VEICOLA 365 GTC 4
POSIZIONAMENTO TUBAZIONI SCARICO.

CIRCOLARE TECNICA N°19.
DATA. 16-5-72

CAR 365 GTC 4
CHECK OF THE EXHAUST SYSTEM POSITIONING.

TECHNICAL
INFORMATION N° 199
DATE. 16-5-72

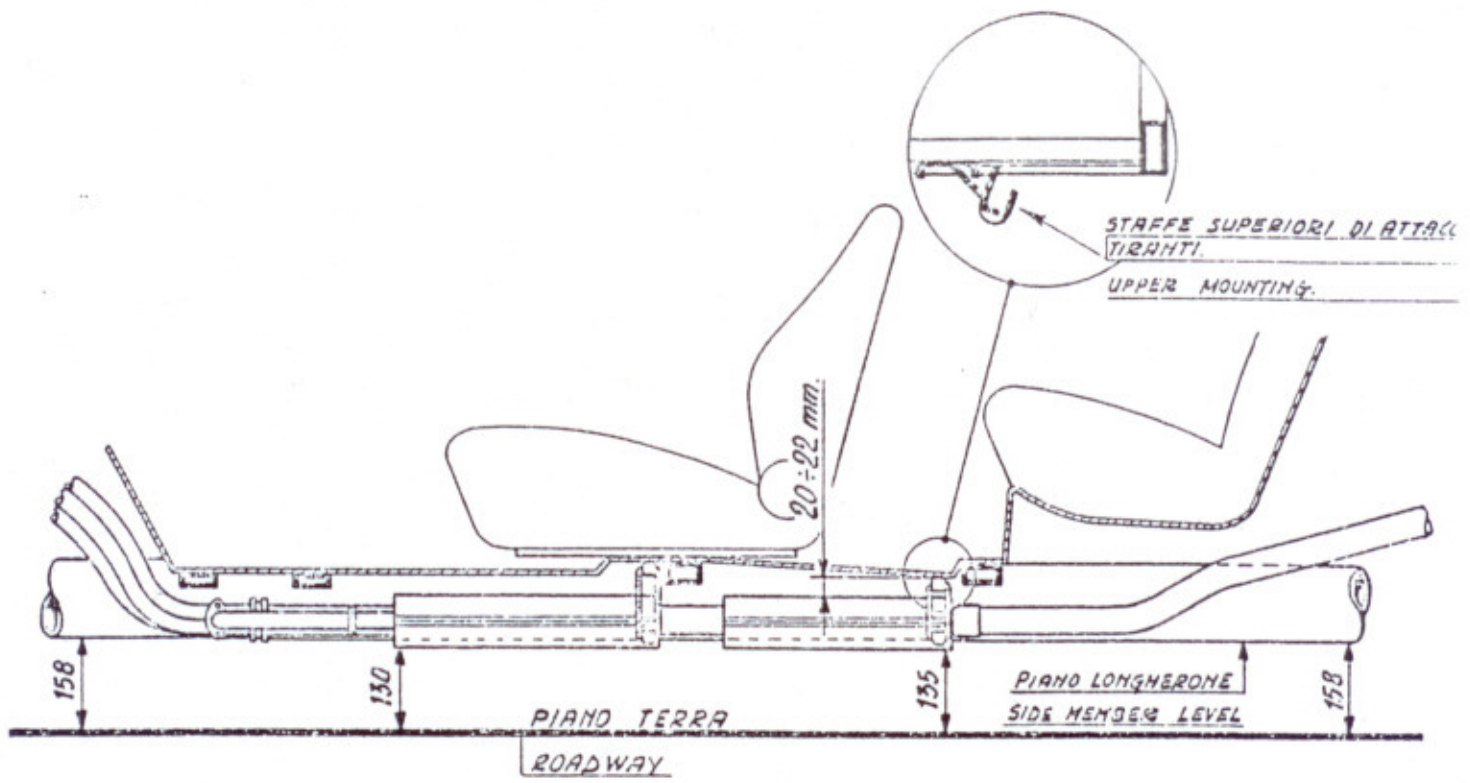
VI PREGHIAMO DI VERIFICARE SU TUTTE LE VETTURE IL POSIZIONAMENTO DEGLI SCARICHI CON PARTICOLARE RIFERIMENTO ALLA ZONA SEDE PIEDI PASSEGGERI POSTERIORI. NELLO SCHIZZO ABBIAMO INDICATO L'ESATTO POSIZIONAMENTO, COMUNQUE CONSIGLIAMO DI VERIFICARE CHE LA DISTANZA DAL PIANALE ALLE MARMITTE SIA DI mm. 20÷22 NEL PUNTO PIÙ VICINO. VI CONSIGLIAMO DI AGIRE SE NECESSARIO SULLE STAFFE SUPERIORI DI ATTACCO TIRANTI.

WE KINDLY ASK YOU TO CHECK ON ALL GTC 4 THE POSITIONING OF EXHAUST SYSTEM PARTICULARLY TAKING CARE OF THE AREA FOR REAR PASSENGERS SIDE BOTTOM. IN THE ABOVE DRAWING WE HAVE SHOWN THE CORRECT POSITIONING; HOWEVER WE RECOMMEND TO CHECK THAT THE DISTANCE BETWEEN THE PLANE OF THE BODY AND THE EXHAUST SILENCER IS 20÷22 mm. IN THE NEAREST POINT. IF NECESSARY WE RECOMMEND TO OPERATE ON THE UPPER MOUNTING.
